R21BN

DATE: March 23, 2022
TO: Blue Bird Owners
Subject: R21BN: Hydraulic Brake Line Rub on Ford 7.3L

NHTSA Recall Number: 21V-778 School Bus

R21BN: Hydraulic Brake Line Rub on Ford 7.3L

Illustration 1

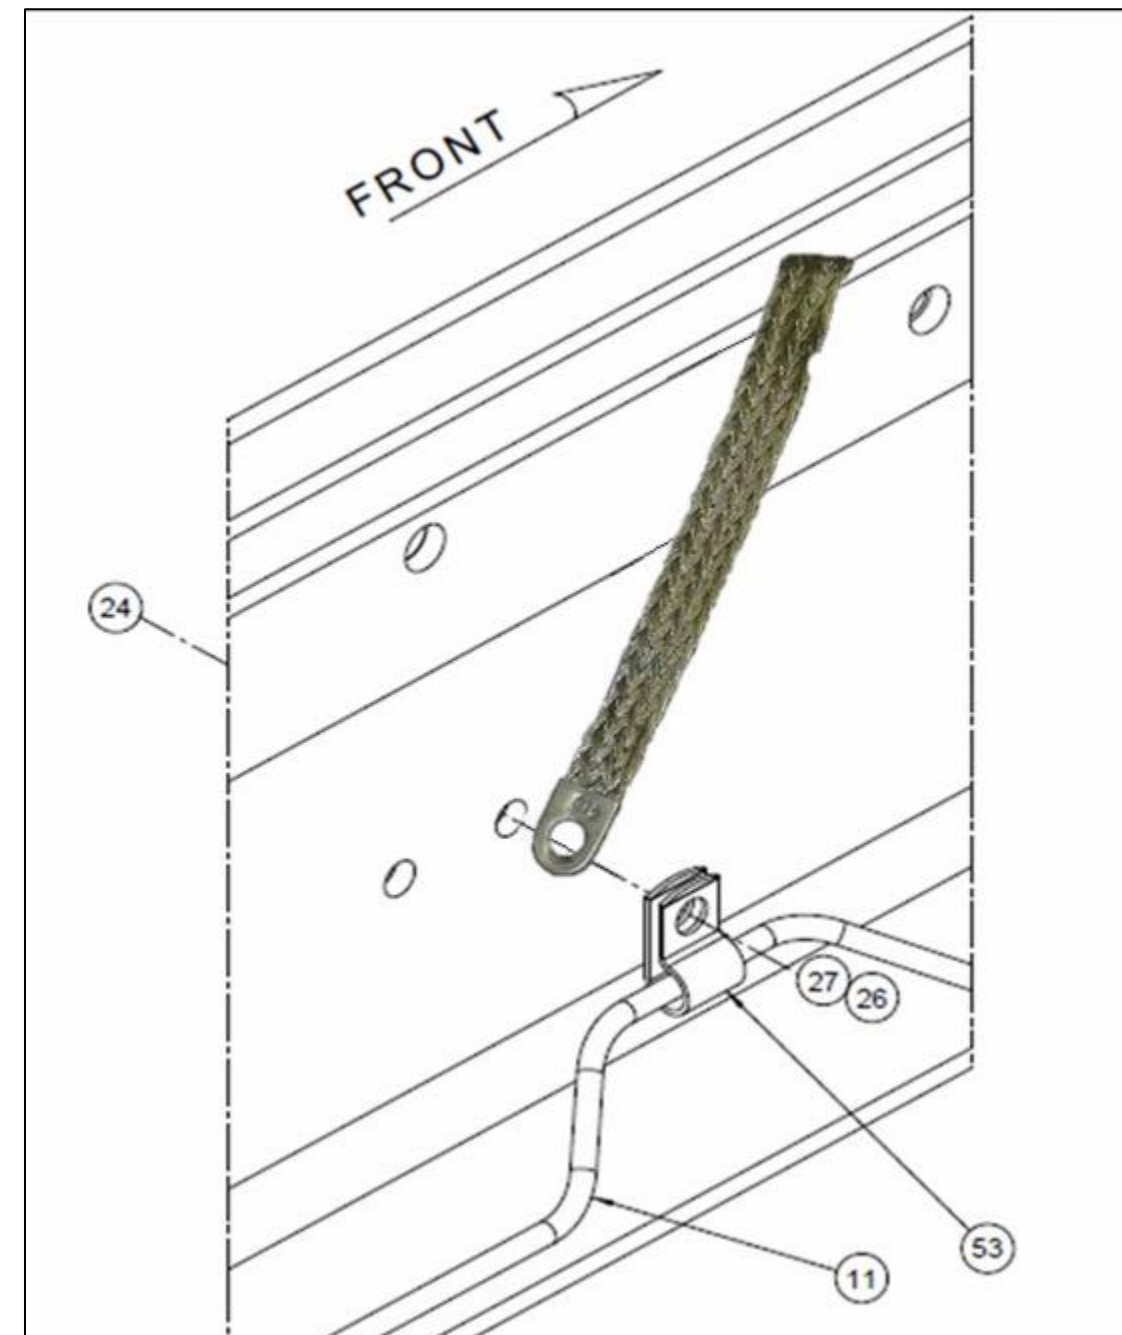
Issue: The left-hand, front hydraulic brake line on certain units may not be properly secured.

- Locate the left-hand front brake line, inside the frame rail, rear of the front motor mount.
- Inspect for a “P” clamp (Item #53) securing the hydraulic brake line to the frame rail at the grounding strap.
 - If the clamp is installed, tight and positioned per Illustration 1, no further action is necessary.
 - If the clamp is missing or incorrectly installed, proceed to the next step.
- Locate the mounting fastener for the engine ground strap. Remove the locking nut securing ground strap to chassis and discard the nut.

Corrective Action: Install P-Clamp over brake line in a downward position, securing the brake line to the frame rail.

- Install P-Clamp 02024370 (Item 53) over brake line, oriented in a downward position, with the flat side of the P-Clamp against the frame rail.
- Insert capscrew and washer (Items 26 & 27) thru the P-Clamp, ground strap and frame rail.

- Install new locknut (Item 24) onto the capscrew on the outside of the frame rail.
- While ensuring the ground strap and P-Clamp are properly positioned, tighten the lock nut and torque to 30 ft-lbs.

*IMPORTANT: The stack of components is critical. Proper sequence is frame, ground strap then P-Clamp
Do not install P-Clamp between frame and ground strap.*
